**STAFF REPORT 07-10-2019 MEETING**  
**APPLICATION NUMBER: 19-6304**  
**ADDRESS: 14933 ARTESIAN STREET**  
**HISTORIC DISTRICT: ROSEDALE PARK**  
**APPLICANT: MARYANN REA, SUNRISE BUILDING**  
**STAFF SITE VISIT: 07-02-2019**

**PREPARED BY: A. PHILLIPS**

With the current proposal, the applicant is seeking the Commission's approval **to demolish the existing 20' x 20' and erect a new 24' x 24' wood frame garage per the attached drawings**. Including the following scope items:

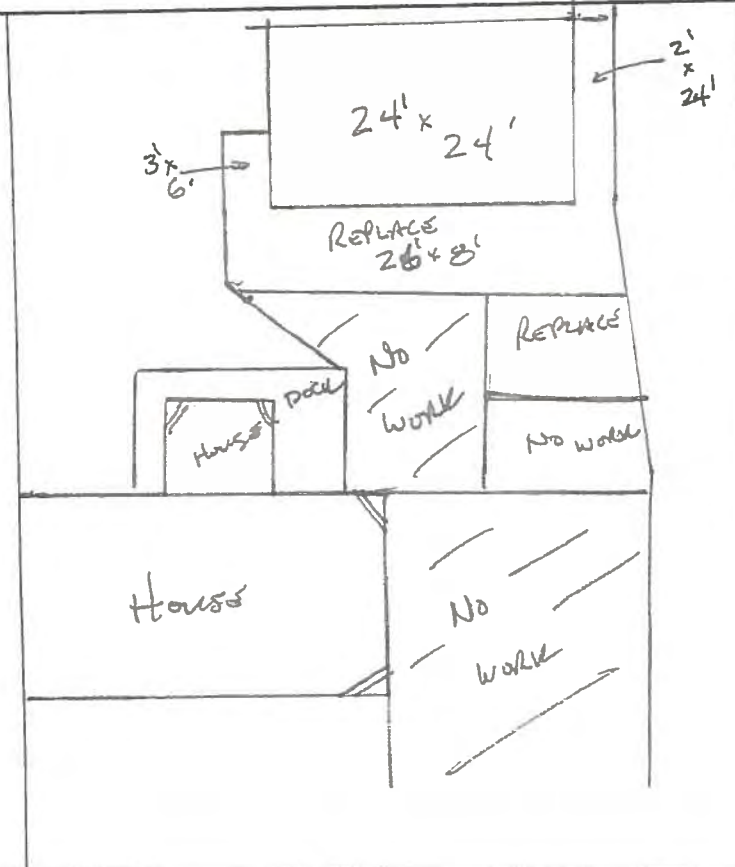
color and specification of the shingles was not provided by the applicant. The garage door is proposed to be a “steel sectional” door that is 16’ x 8’ in size and will be white in color (see attached photos). The electrical service included in the application include “3 plugs, 3” lights, 3 plugs.” It is unknown whether the plugs and lights are to be on the interior or exterior of the garage. The current application does not include a person-door or windows.

WALL SECTION      1/2" = 1'-0"

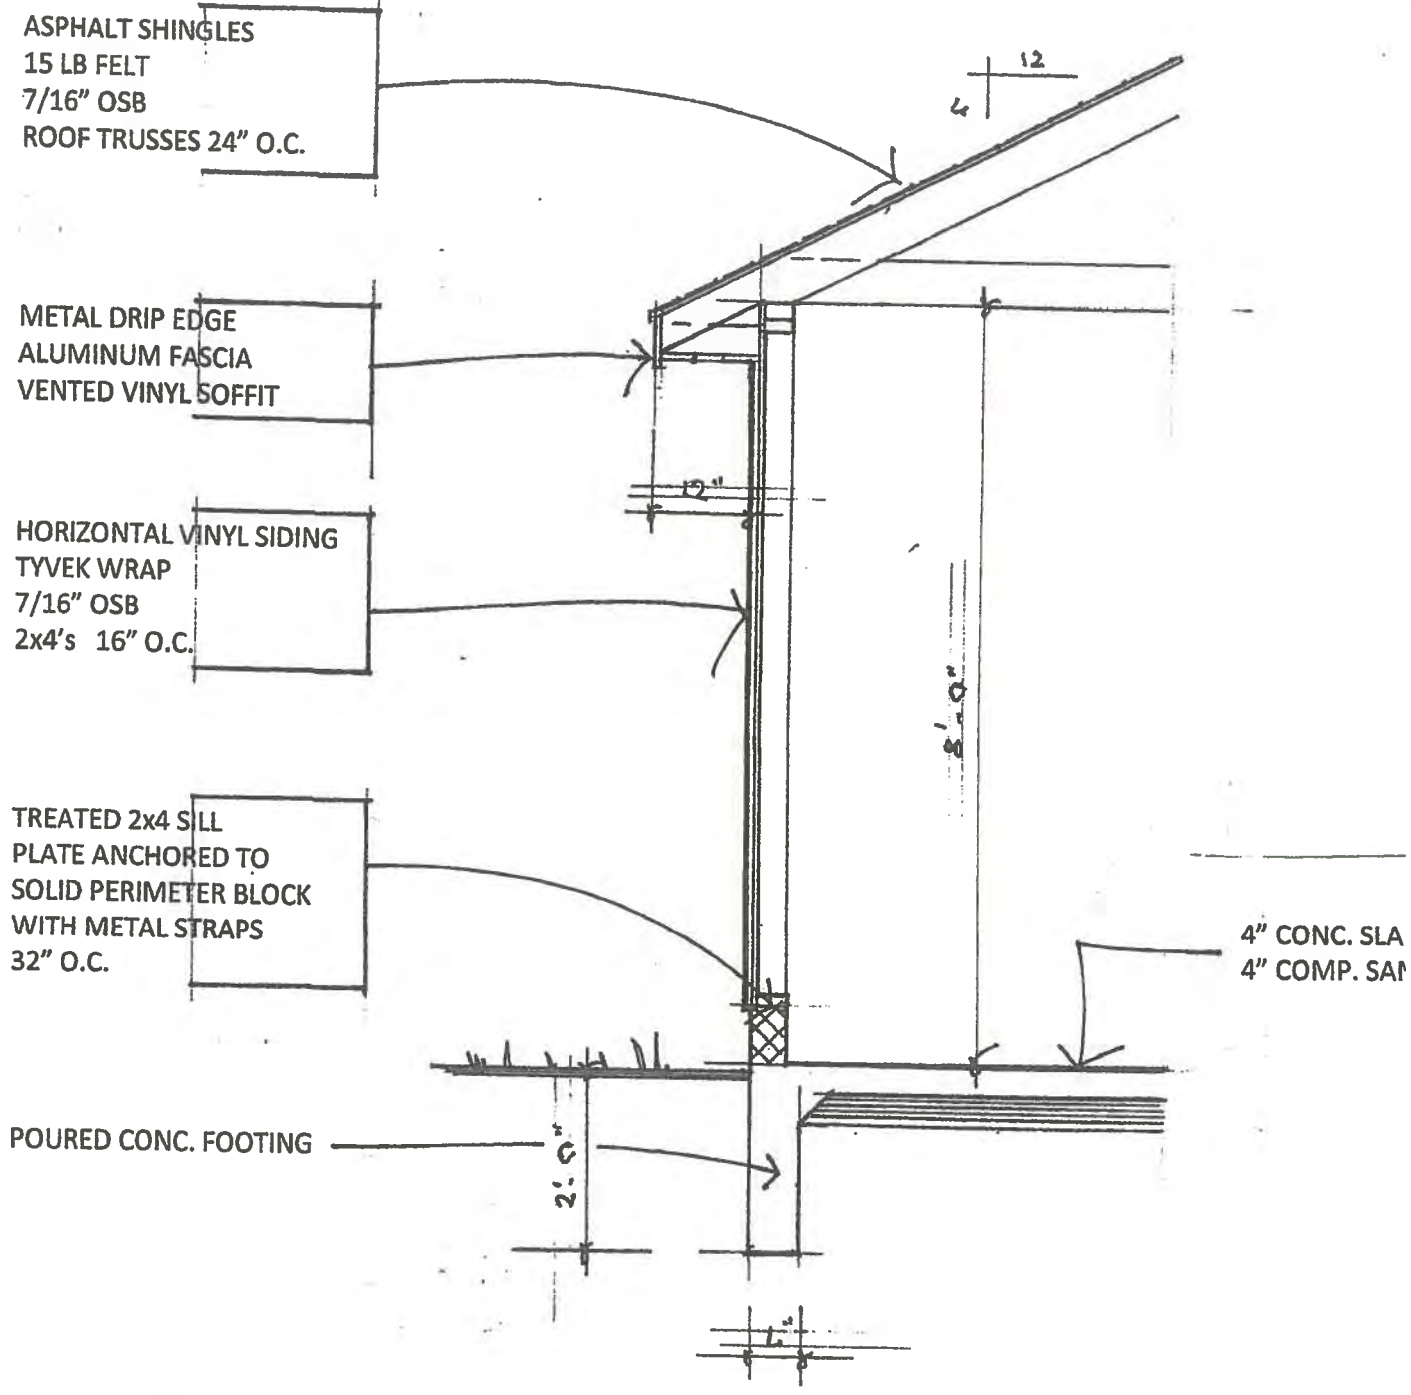
Given the recent discussion held amongst Commissioners at the June 26, 2019 HDC meeting regarding the appropriateness of the use of vinyl (windows, fences, siding, etc.), staff is concerned about the appropriateness of the proposed vinyl siding for the new garage.

- The proposed siding should be of a more appropriate material than vinyl
